ZONING CHANGE REVIEW SHEET

CASE: C814-2017-0001 – 425 W. Riverside PUD

ADDRESS: 425 W. Riverside Drive

ZONING FROM: CS-1-V-NP **TO:** PUD-NP

EXHIBIT C - LAND USE PLAN

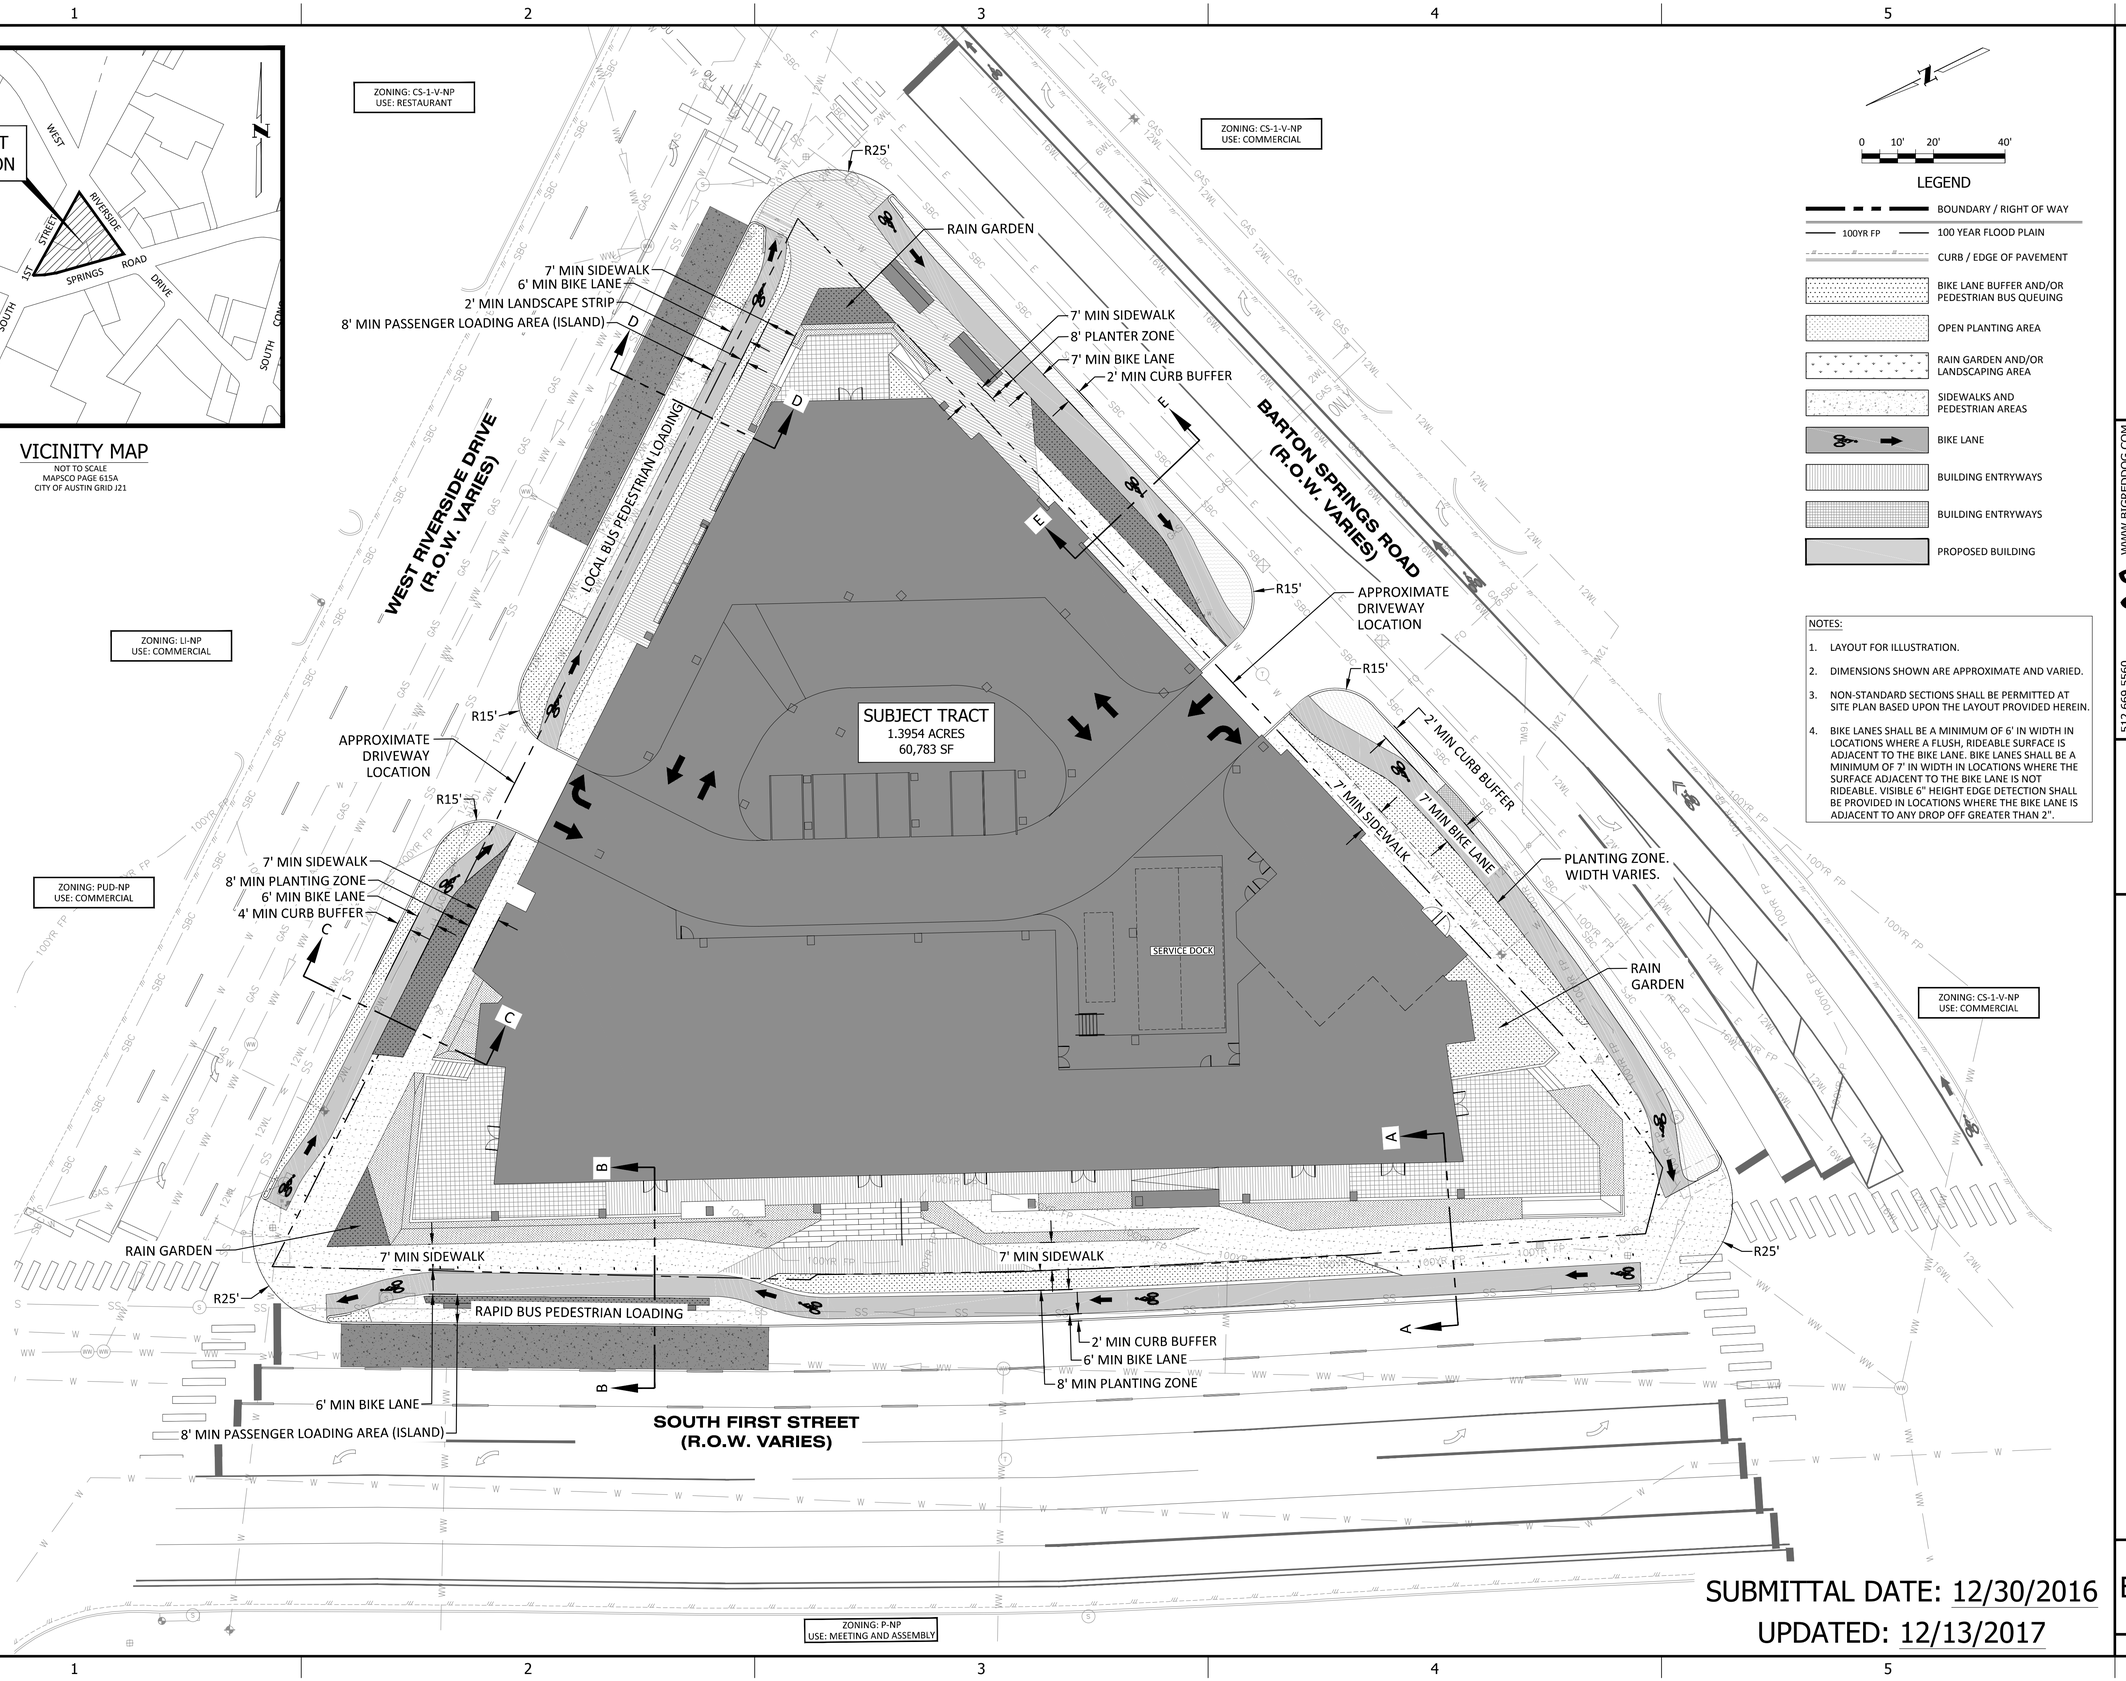
#1 Corner radiuses: I'm OK with the 25' radius representation on the land use plan – Exhibit C under the assumption that these show effective radiuses and that details of ADA ramp and bikeway configurations and actual curb radiuses will be decided at site plan (while conforming to the effective radius.

#2 On exhibit C, note 4 should be removed. In the above comment we need to retain the ability to design the corners and bikeway interactions at site plan. A single curb ramp is not preferred from an pedestrian / bicycle design and may not align with ADA requirement / best practices.

#3 Bicycle Lane Width - the bicycle lane widths do not conform to the original drawing I sent in May. In the attached Exhibit C and E I have marked up width changes. In short the following are the dimentional requirements for the bicycle lane in a few scenarios: If pavement on either side of bicyle lane is not ridable than 7' is the minimum bikeway dimention.

EXHIBIT E

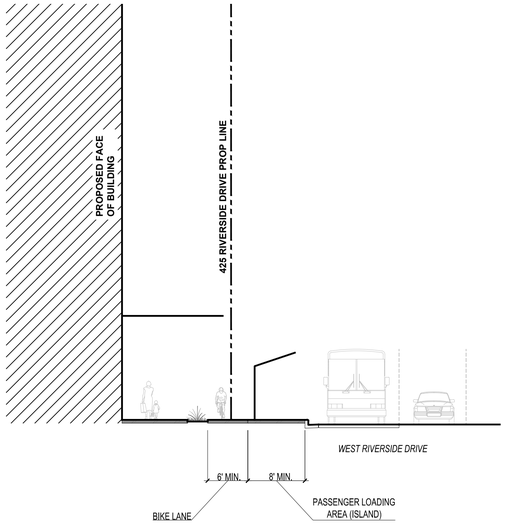
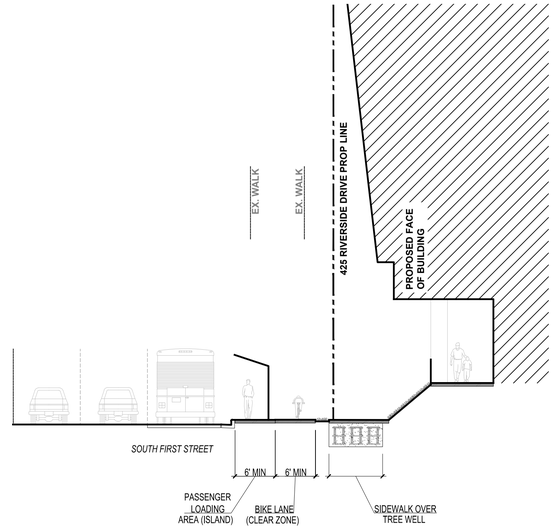
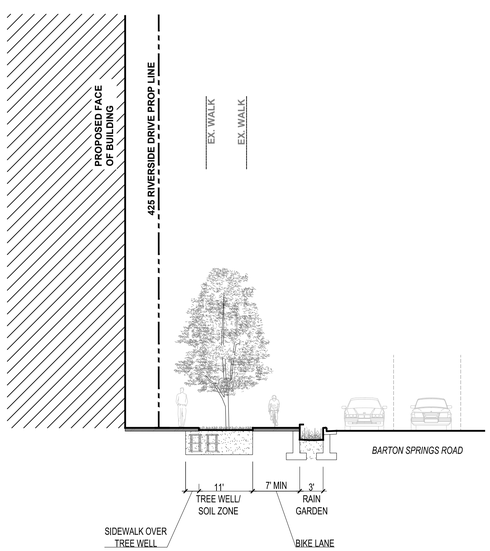
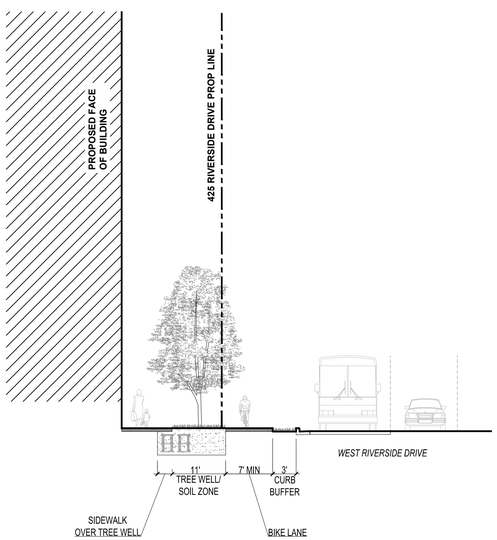
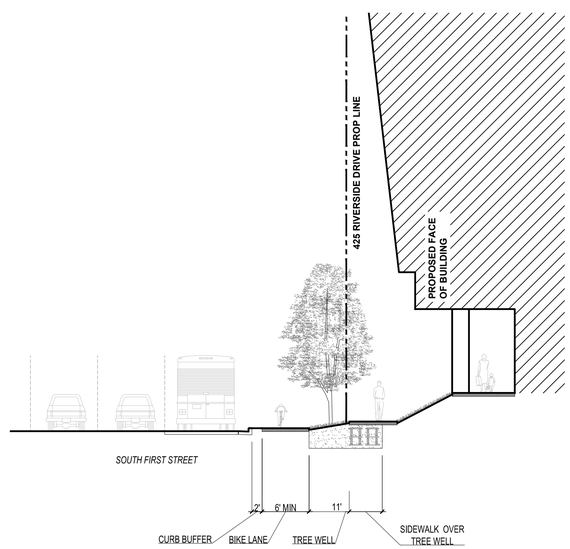
If there is a dropoff into a rain garden there needs to be a hand rail that is recessed from the bike lane by 6" as to not incroach in the bicycle lane space (handrails should be added to re;evamt cross sections in exhibit E. If there is ridable pavement on both sides of the bike lane the minimum acceptable dimention is 6'
